Subject: Sydney Metro West Stage 1 – Western Tunnelling Package, North Strathfield Power Enabling Works (Phase J) – Approval of Heavy Vehicle Local Roads Report

Heavy Vehicle Local Road (HVLR) Assessment

North Strathfield Heavy Vehicle Local Road
Approval for Sydney Metro West

Revision 01
Date: 03 November 2025

Figure 1 Extract from EIS reflecting existing approved access

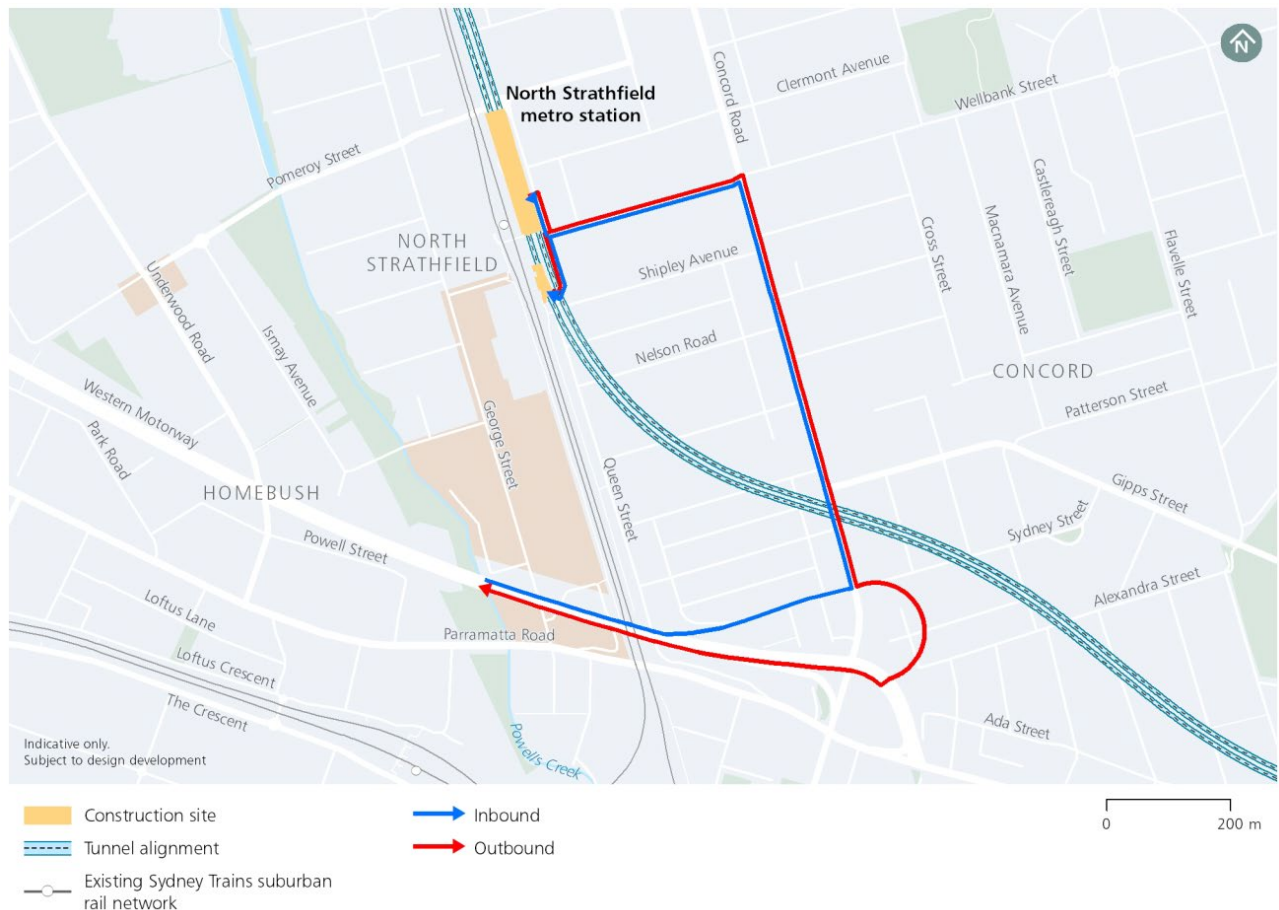
CONTRACT NO.	DOCUMENT NO.	TITLE	VER	STATUS	NO.	DATE	COMPANY	RAISED BY	REVIEW DOC. NO.*	DOCUMENT REF*	DEED REF*	COMMENTS / RESPONSE	COMMENT CATEGORY*
EWNS	SMWSDDS-S	EWNS - Heavy Veh	01.01	RVW	06	15/10/2025	HBI	GKOLLIAS	CLNK-SYNC-HVLR-NTS	Multiple	-	Remove references to CoA E104, E105 and E107 throughout and replace with equivalent CoA condition as required	Observation
EWNS	SMWSDDS-S	EWNS - Heavy Veh	01.01	RVW					CLNK-SYNC-HVLR-NTS	Multiple	-		Observation
EWNS	SMWSDDS-S	EWNS - Heavy Veh	01.01	RVW	06.01	29/10/2025	SYS	AWASHINGTON	CLNK-SYNC-HVLR-NTS	Multiple	-	This has been updated.	Observation
EWNS	SMWSDDS-S	EWNS - Heavy Veh	01.01	RVW					CLNK-SYNC-HVLR-NTS	Multiple	-		Observation
EWNS	SMWSDDS-S	EWNS - Heavy Veh	01.01	RVW	07	15/10/2025	HBI	GKOLLIAS	CLNK-SYNC-HVLR-NTS	Sect 3.1 & Figure 1	D86	EIS Technical Paper 1 – Traffic and Transport Sect 4.12 and Figure 4-29 have the assessed route as "Roads forming part of the construction vehicle route include the M4 Western Motorway, Concord Road, Wellbank Street and Queen Street as shown in Figure 4-29". These same roads are used for Outbound. Route and Figure used if for upcoming Stage of Sydney Metro West, and not the approved Project. Check all assessments and information used throughout HVLR are against the relevant EIS. Pomeroy and Underwood Outbound have not been assessed as part of the correct EIS, and therefore may need further assessment in this document. Revise Sect 3.1 and Figure 1	Actual Non-Compliance

EWNS	SMWSDDS-S	EWNS - Heavy Veh	01.01	RVW					CLNK-SYNC-HVLR-NTS	Sect 3.1 & Figure 1	D86		Actual Non-Compliance
EWNS	SMWSDDS-S	EWNS - Heavy Veh	01.01	RVW	07.01	29/10/2025	SYS	AWASHINGTON	CLNK-SYNC-HVLR-NTS	Sect 3.1 & Figure 1	D86	Noted, however these are Regional Roads and not 'Local Roads' as described in the document and would therefore not meet the classification or criteria for needing further assessment based on their classification. This is already noted in section 3.2.	Actual Non-Compliance
EWNS	SMWSDDS-S	EWNS - Heavy Veh	01.01	RVW					CLNK-SYNC-HVLR-NTS	Sect 3.1 & Figure 1	D86		Actual Non-Compliance
EWNS	SMWSDDS-S	EWNS - Heavy Veh	01.01	RVW	08	15/10/2025	SMD	RBANZON	SMWSDDS-SYS-NST-TF-REP-000010	Section 1	D86, D87, D88 and D89	Please update the referenced conditions to the relevant EIS Stage 1 MCoA	Actual Non-Compliance
EWNS	SMWSDDS-S	EWNS - Heavy Veh	01.01	RVW					SMWSDDS-SYS-NST-TF-REP-000010	Section 1	D86, D87, D88 and D89		Actual Non-Compliance

Figure 2 Road network classifications (<https://maps.transport.nsw.gov.au/egeomaps/road-network-classification/index.html>)

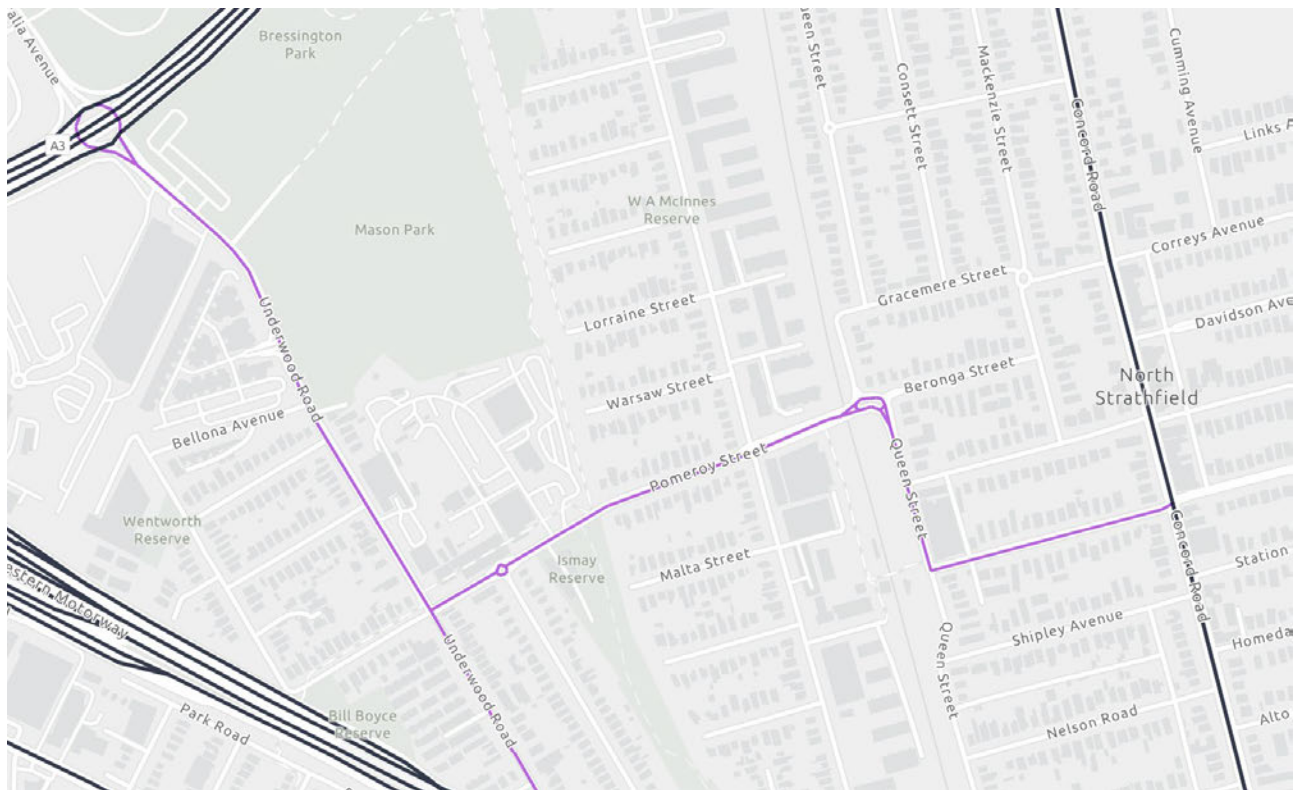
EWNS	SMWSDDS-S	EWNS - Heavy Veh	01.01	RVW					SMWSDDS-SYS-NST-TF-REP-000010	Section 1.2 Table 1	MCoA Traffic and Transport		Actual Non-Compliance
EWNS	SMWSDDS-S	EWNS - Heavy Veh	01.01	RVW	10	15/10/2025	SMD	RBANZON	SMWSDDS-SYS-NST-TF-REP-000010	Section 3.1 Flgure 1	N/A	EIS extract is from the Stage 3 EIS. Please replace with the Stage 1 EIS and update the commentary as required.	Observation
EWNS	SMWSDDS-S	EWNS - Heavy Veh	01.01	RVW					SMWSDDS-SYS-NST-TF-REP-000010	Section 3.1 Flgure 1	N/A		Observation
EWNS	SMWSDDS-S	EWNS - Heavy Veh	01.01	RVW	10.01	29/10/2025	SYS	AWASHINGTON	SMWSDDS-SYS-NST-TF-REP-000010	Section 3.1 Figure 1	N/A	This has been updated.	Observation
EWNS	SMWSDDS-S	EWNS - Heavy Veh	01.01	RVW					SMWSDDS-SYS-NST-TF-REP-000010	Section 3.1 Figure 1	N/A		Observation
EWNS	SMWSDDS-S	EWNS - Heavy Veh	01.01	RVW	11	15/10/2025	SMD	RBANZON	SMWSDDS-SYS-NST-TF-REP-000010	Section 3.2	N/A	Given that Pomeroy St, Underwood Road and Homebush Bay Drive are not approved in the Stage 1 EIS, the Figure 2 map extents should be cover these roads as well.	Observation

CONTRACT NO.	DOCUMENT NO.	TITLE	VER	STATUS	NO.	DATE	COMPANY	RAISED BY	REVIEW DOC. NO.*	DOCUMENT REF*	DEED REF*	COMMENTS / RESPONSE	COMMENT CATEGORY*
EWNS	SMWSDDS-S	EWNS - Heavy Veh	01.01	RVW					SMWSDDS-SYS-NST-TF-REP-000010	Section 3.2	N/A		Observation
EWNS	SMWSDDS-S	EWNS - Heavy Veh	01.01	RVW	11.01	29/10/2025	SYS	AWASHINGTON	SMWSDDS-SYS-NST-TF-REP-000010	Section 3.2	N/A	This has been updated.	Observation
EWNS	SMWSDDS-S	EWNS - Heavy Veh	01.01	RVW					SMWSDDS-SYS-NST-TF-REP-000010	Section 3.2	N/A		Observation
EWNS	SMWSDDS-S	EWNS - Heavy Veh	01.01	RVW	12	15/10/2025	SMD	RBANZON	SMWSDDS-SYS-NST-TF-REP-000010	Section 3.3	N/A	Commentary should be updated to mention that access and egress also uses a combination of regional roads that are discussed in the CTMP.	Observation
EWNS	SMWSDDS-S	EWNS - Heavy Veh	01.01	RVW					SMWSDDS-SYS-NST-TF-REP-000010	Section 3.3	N/A		Observation
EWNS	SMWSDDS-S	EWNS - Heavy Veh	01.01	RVW	12.01	29/10/2025	SYS	AWASHINGTON	SMWSDDS-SYS-NST-TF-REP-000010	Section 3.3	N/A	This has been added.	Observation

Figure 3 Proposed additional heavy vehicle access and egress

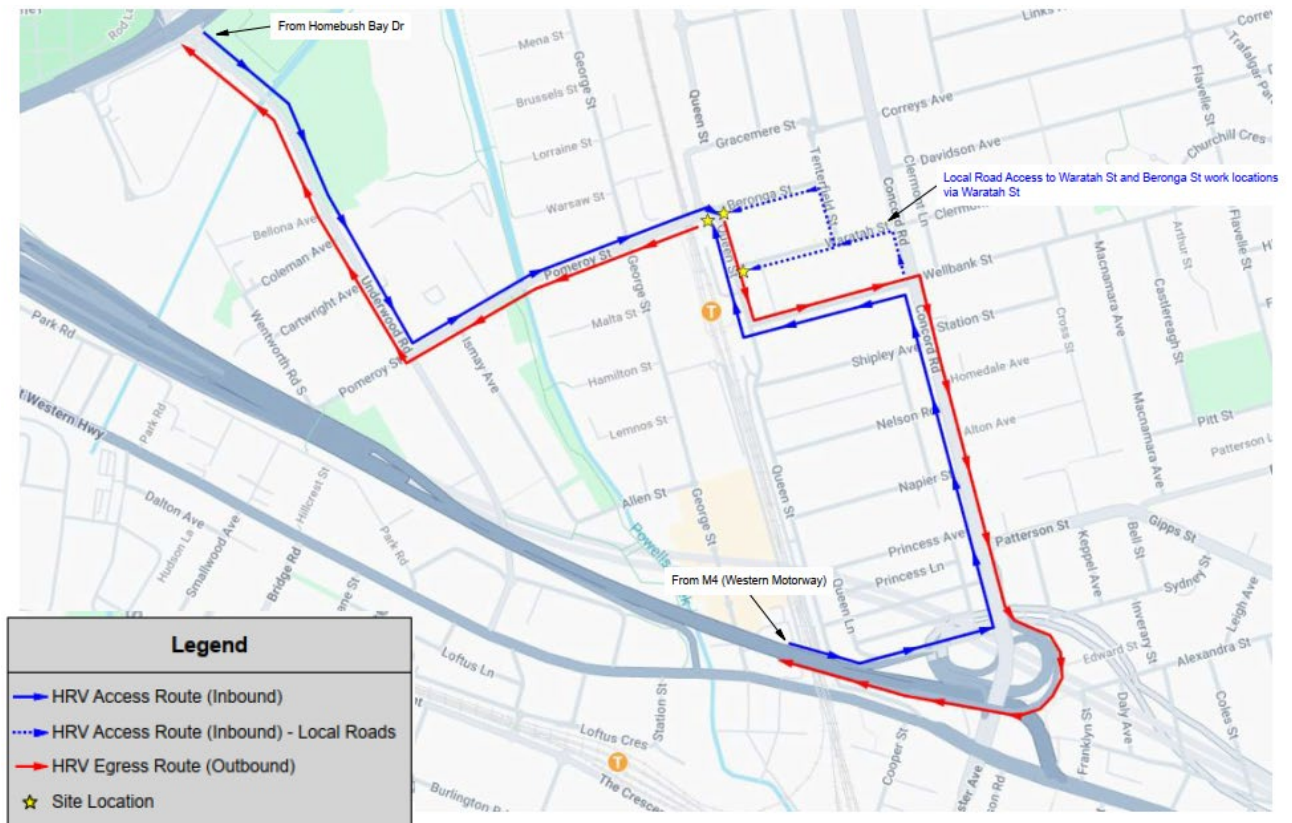
EWNS	SMWSDDS-S	EWNS - Heavy Veh	01.01	RVW					SMWSDDS-SYS-NST-TF-REP-000010	Section 3.3	N/A		Observation
EWNS	SMWSDDS-S	EWNS - Heavy Veh	01.01	RVW	13	15/10/2025	SMD	RBANZON	SMWSDDS-SYS-NST-TF-REP-000010	Section 3.3 Figure 3 and Figure 4	N/A	Please add a key to the figures to show that the blue line is access/ingress and the pink line is egress	Observation
EWNS	SMWSDDS-S	EWNS - Heavy Veh	01.01	RVW					SMWSDDS-SYS-NST-TF-REP-000010	Section 3.3 Figure 3 and Figure 4	N/A		Observation
EWNS	SMWSDDS-S	EWNS - Heavy Veh	01.01	RVW	13.01	29/10/2025	SYS	AWASHINGTON	SMWSDDS-SYS-NST-TF-REP-000010	Section 3.3 Figure 3 and Figure 4	N/A	This has been updated in the VMP figure, and the legend is included for clarity.	Observation
EWNS	SMWSDDS-S	EWNS - Heavy Veh	01.01	RVW					SMWSDDS-SYS-NST-TF-REP-000010	Section 3.3 Figure 3 and Figure 4	N/A		Observation
EWNS	SMWSDDS-S	EWNS - Heavy Veh	01.01	RVW	14	15/10/2025	SMD	RBANZON	SMWSDDS-SYS-NST-TF-REP-000010	Section 3.4 Figure 5	N/A	Please replace the EIS Stage 3 graph with the EIS Stage 1 graph, and update the commentary as required	Observation

EWNS	SMWSDDS-S	EWNS - Heavy Veh	01.01	RVW					SMWSDDS-SYS-NST-TF-REP-000010	Section 3.4 Figure 5	N/A		Observation
EWNS	SMWSDDS-S	EWNS - Heavy Veh	01.01	RVW	14.01	29/10/2025	SYS	AWASHINGTON	SMWSDDS-SYS-NST-TF-REP-000010	Section 3.4 Figure 5	N/A	This has been updated.	Observation
EWNS	SMWSDDS-S	EWNS - Heavy Veh	01.01	RVW					SMWSDDS-SYS-NST-TF-REP-000010	Section 3.4 Figure 5	N/A		Observation
EWNS	SMWSDDS-S	EWNS - Heavy Veh	01.01	RVW	15	15/10/2025	SMD	RBANZON	SMWSDDS-SYS-NST-TF-REP-000010	Section 3.5	N/A	Please update the referenced document to the relevant EIS Stage 1 document	Observation
EWNS	SMWSDDS-S	EWNS - Heavy Veh	01.01	RVW					SMWSDDS-SYS-NST-TF-REP-000010	Section 3.5	N/A		Observation
EWNS	SMWSDDS-S	EWNS - Heavy Veh	01.01	RVW	15.01	29/10/2025	SYS	AWASHINGTON	SMWSDDS-SYS-NST-TF-REP-000010	Section 3.5	N/A	This has been updated, in this instance removed as the Stage 1 document does not appear to provide the same detail.	Observation
